The Mews at Pinnacle Club Amended Final Development Plan
CEC Project 122-008
Project Narrative

THE MEWS AT PINNACLE CLUB

FINAL DEVELOPMENT PLAN

* DENOTES SHEETS THAT WERE REVISED OR ADDED AS PART OF THE AMENDED FINAL DEVELOPMENT PLAN DATED 03-05-2013

date: 03-23-10
 sheet:
L1.02

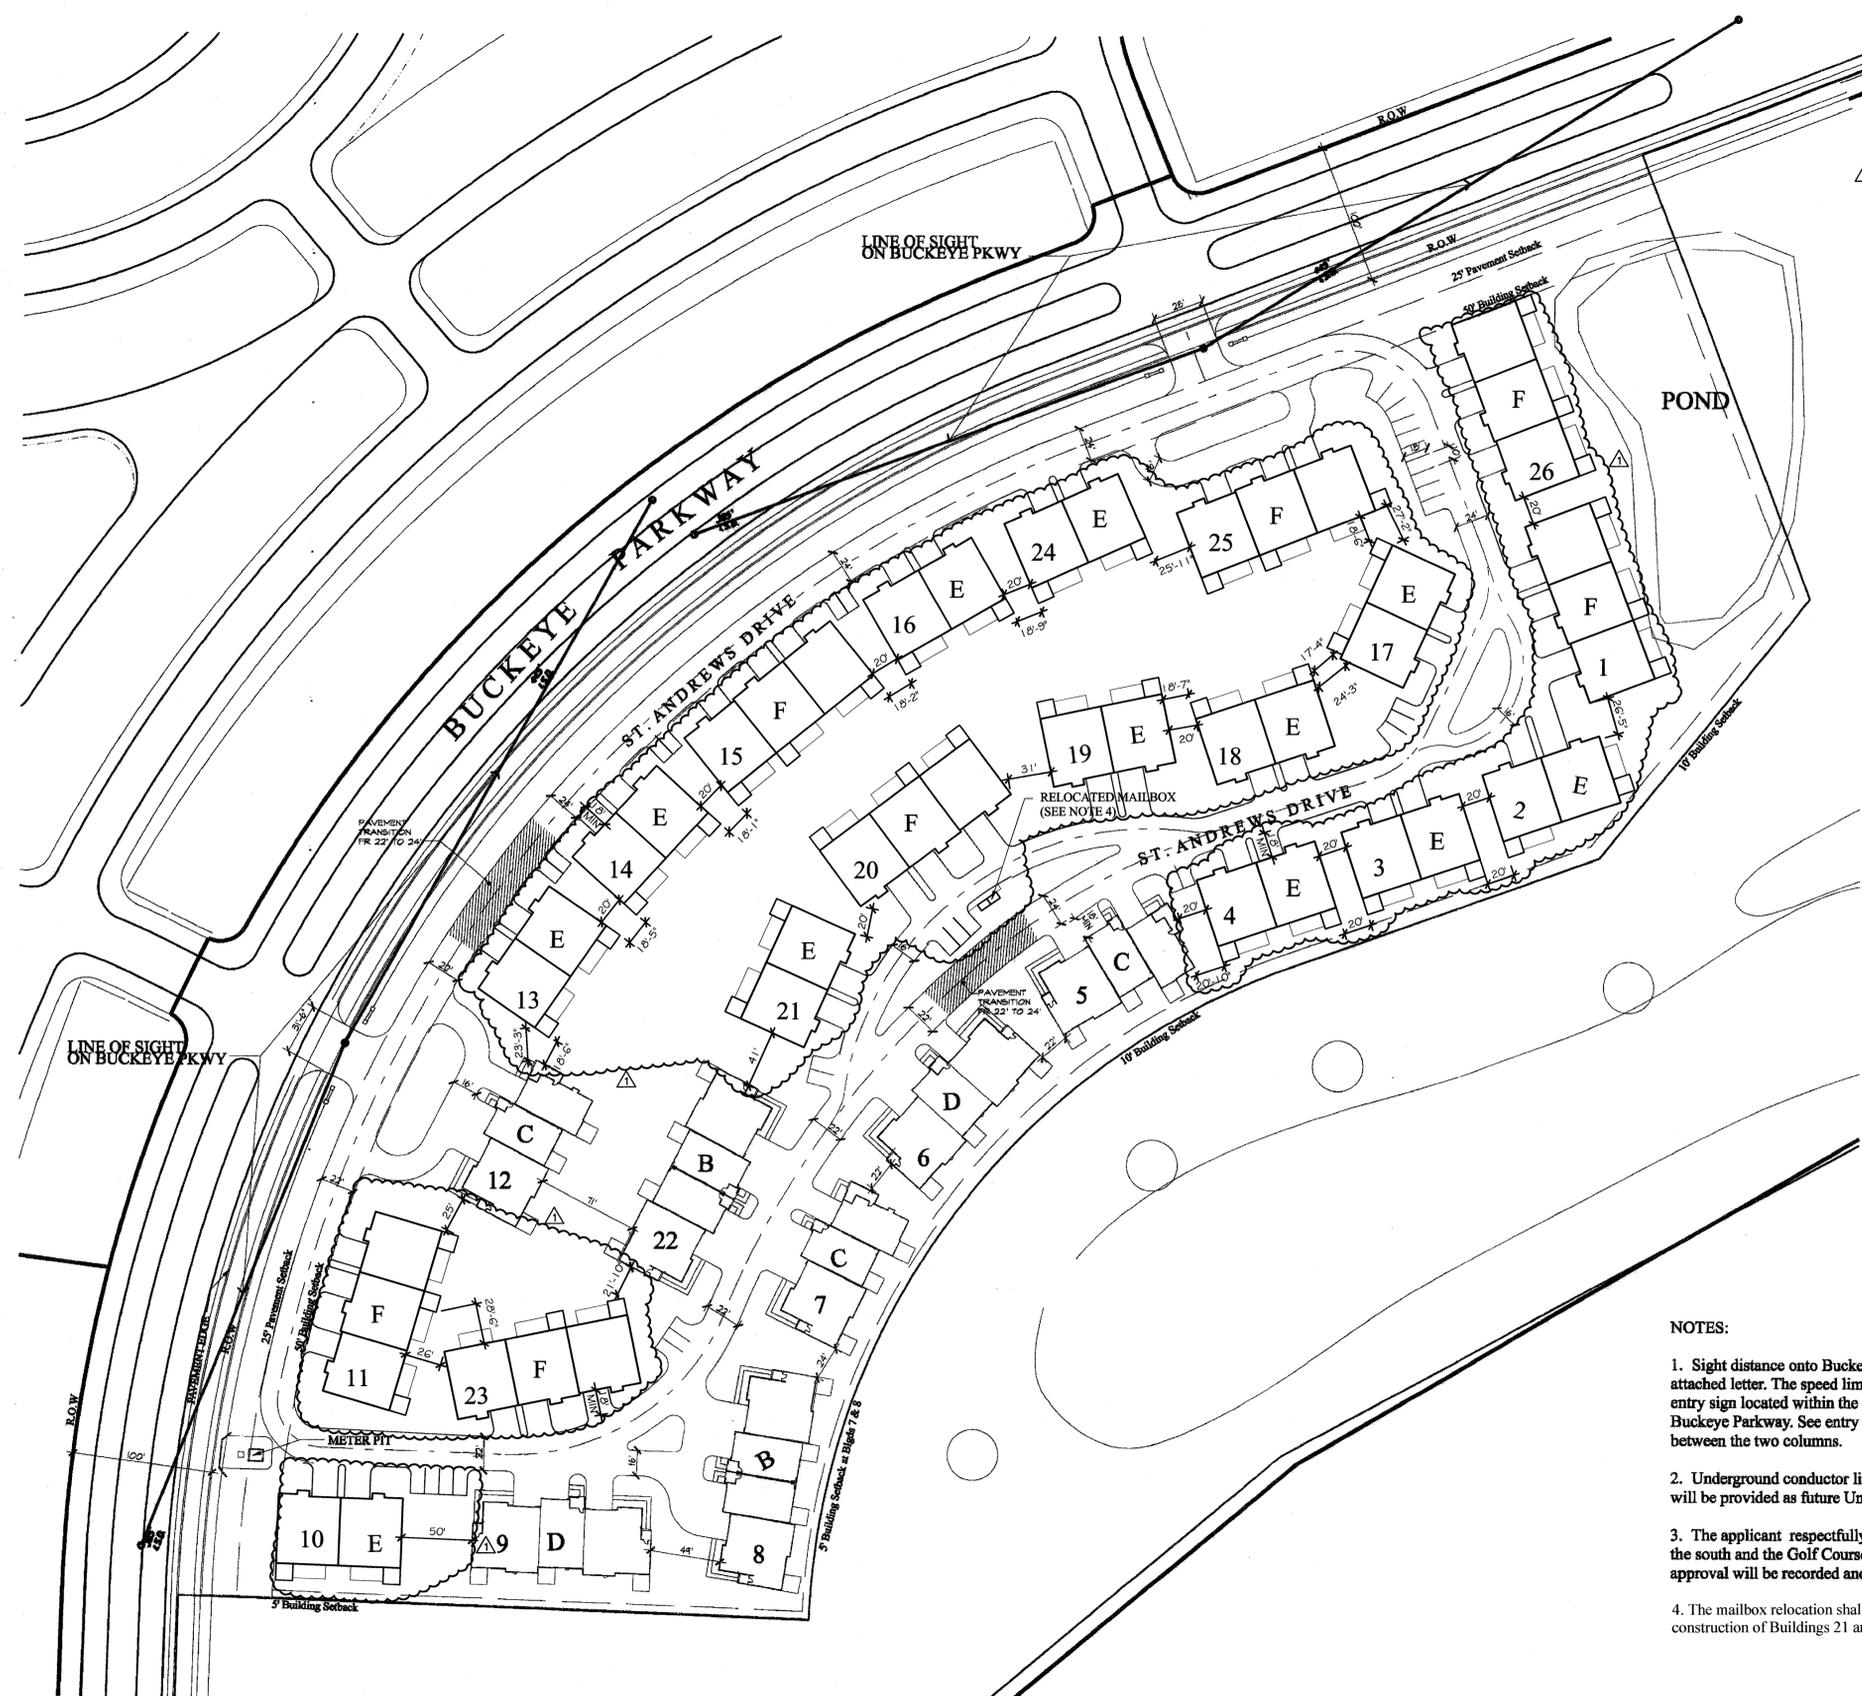
3. The applicant respectfully requests a 5 foot rear-yard setback for Buildings 7, 8 and 9 which are located along the Open Space to the south and the Golf Course to the east to accommodate screened in porches, three season rooms and four season rooms. Setback approval will be recorded and become a public record for future transfers.

4. The mailbox relocation shall be coordinated with the postal inspector. The timing of the relocation shall be synchronized with the construction of Buildings 21 and 20.

REVISION RECORD		
NO	DATE	DESCRIPTION
▲	03/05/13	BUILDING LOCATIONS, DIMENSIONS
▲		
▲		
▲

E1.01

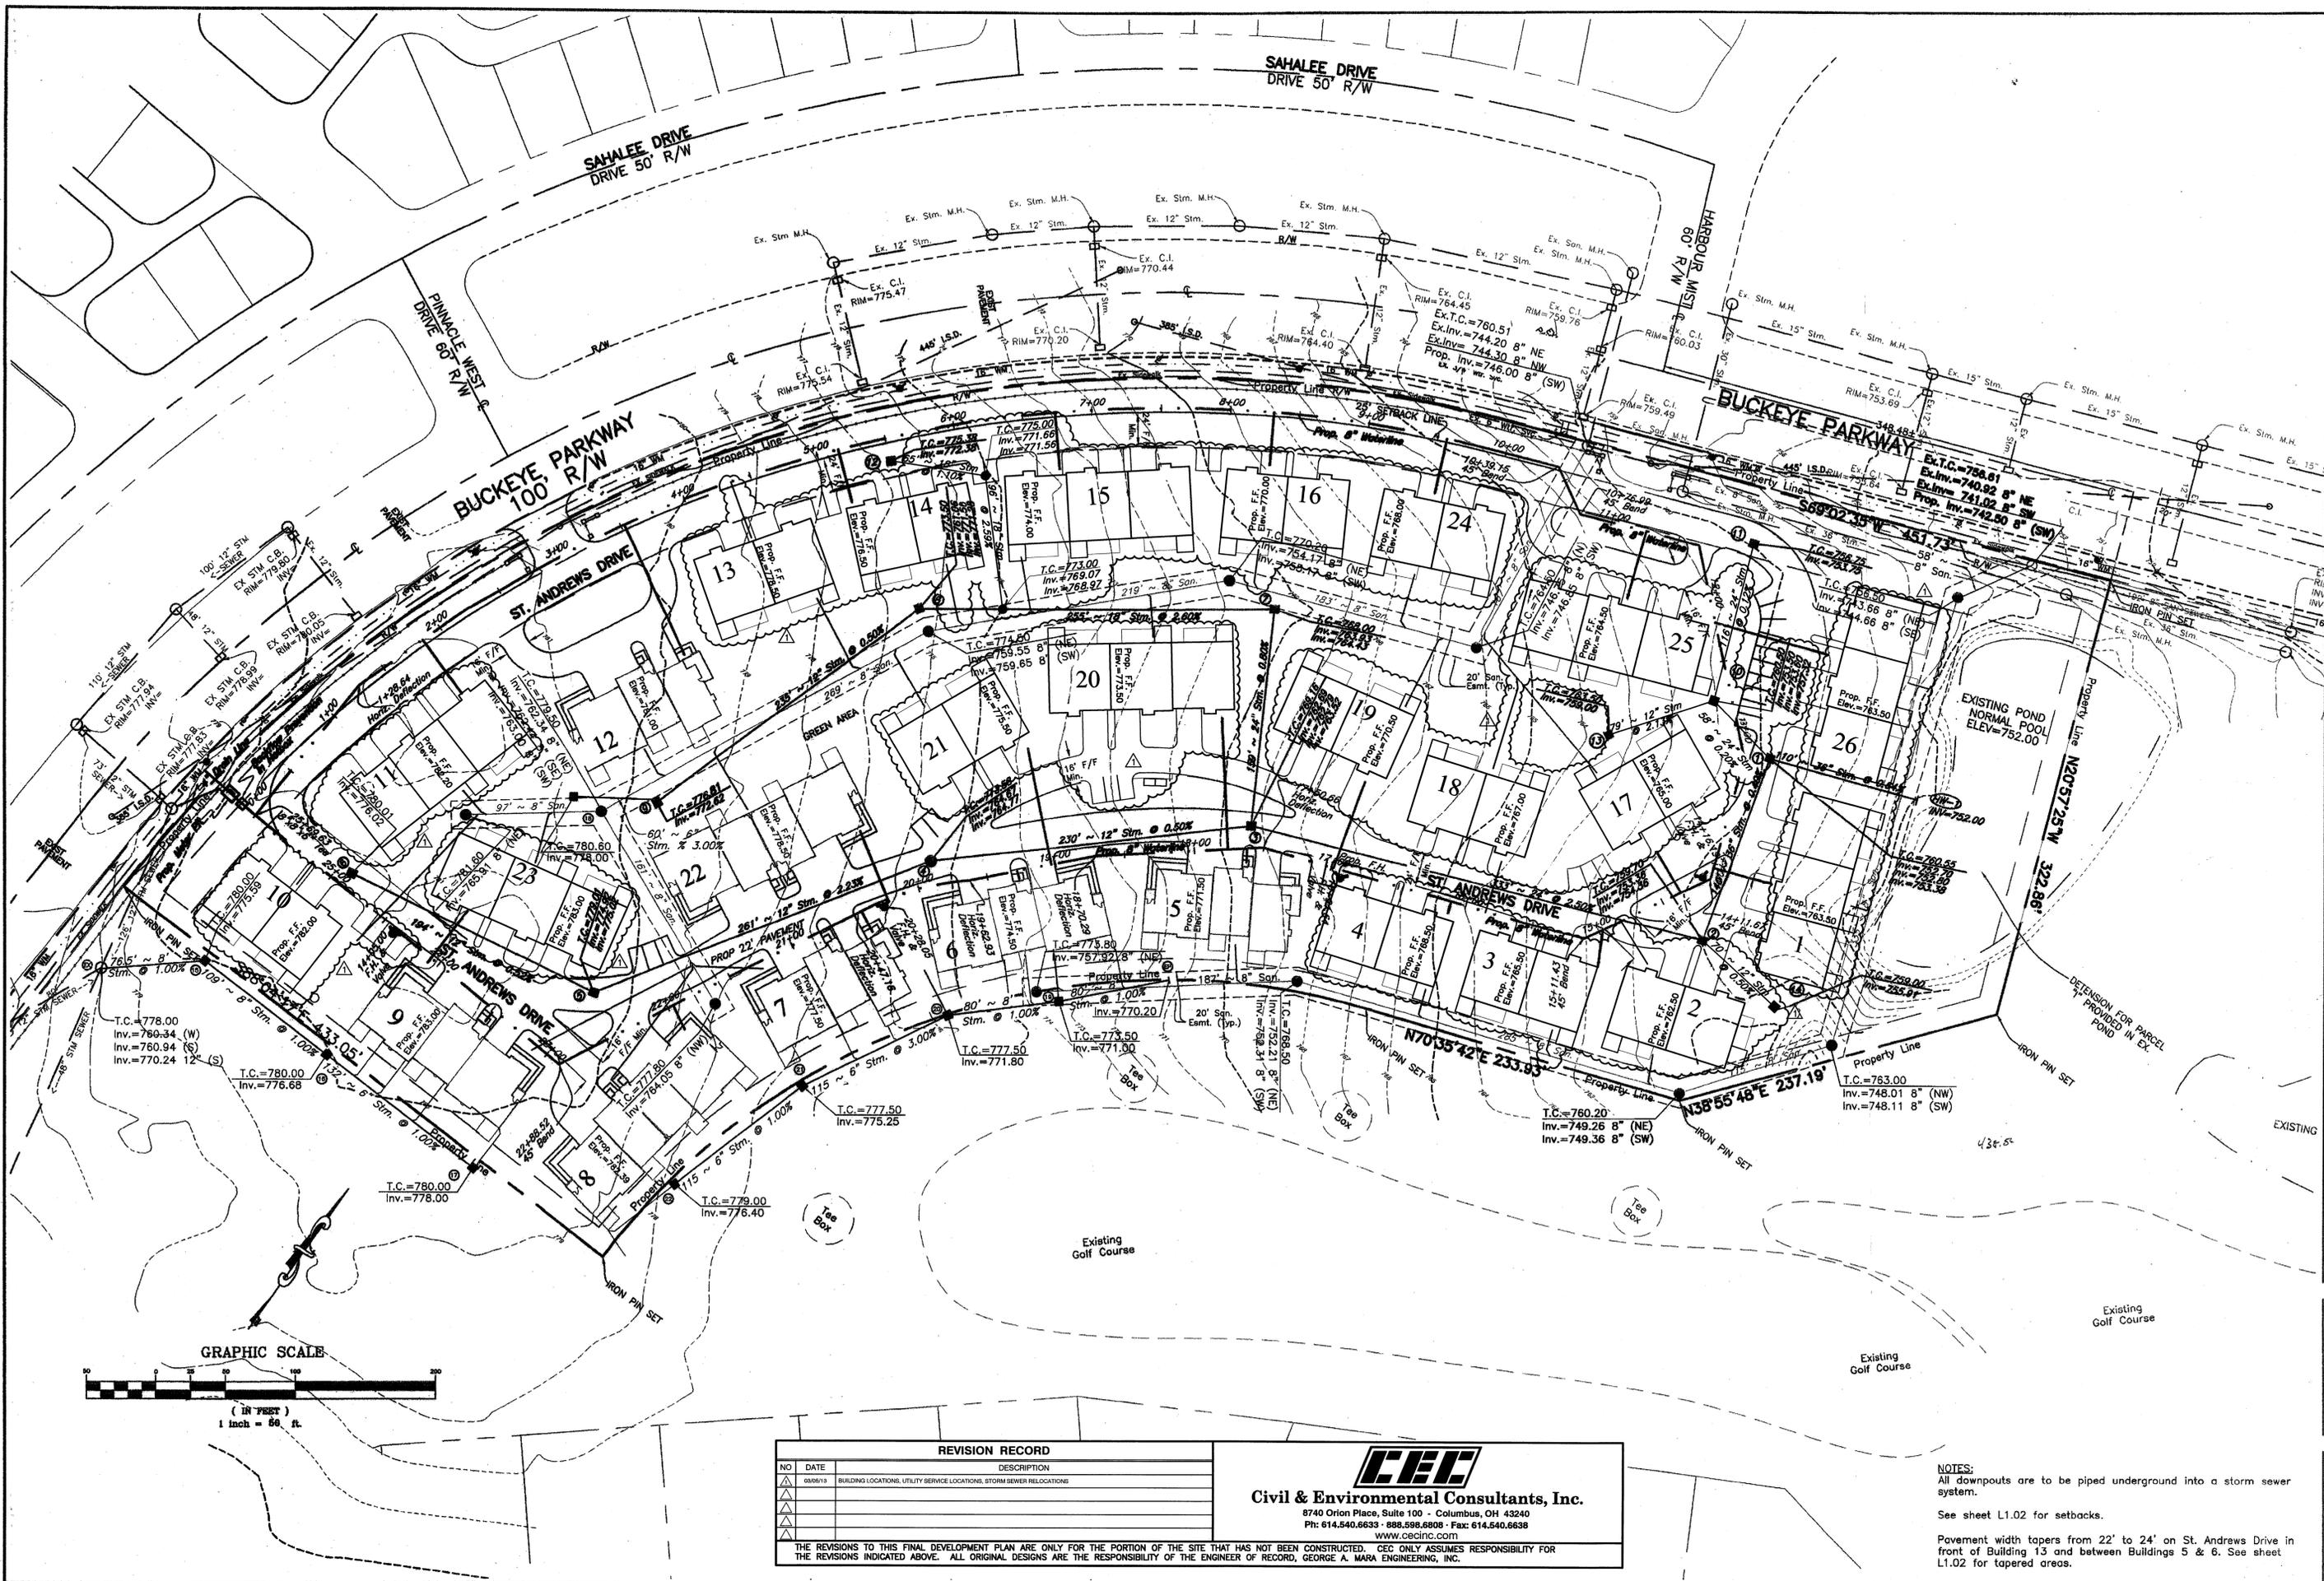
REVISION RECORD		
NO	DATE	DESCRIPTION
1	09/06/10	BUILDING LOCATIONS, UTILITY SERVICE LOCATIONS, STORM SEWER RELOCATIONS

THE REVISIONS TO THIS FINAL DEVELOPMENT PLAN ARE ONLY FOR THE PORTION OF THE SITE THAT HAS NOT BEEN CONSTRUCTED. CEC ONLY ASSUMES RESPONSIBILITY FOR THE REVISIONS INDICATED ABOVE. ALL ORIGINAL DESIGNS ARE THE RESPONSIBILITY OF THE ENGINEER OF RECORD, GEORGE A. MARA ENGINEERING, INC.

NOTES:
 All downpouts are to be piped underground into a storm sewer system.
 See sheet L1.02 for setbacks.
 Pavement width tapers from 22' to 24' on St. Andrews Drive in front of Building 13 and between Buildings 5 & 6. See sheet L1.02 for tapered areas.
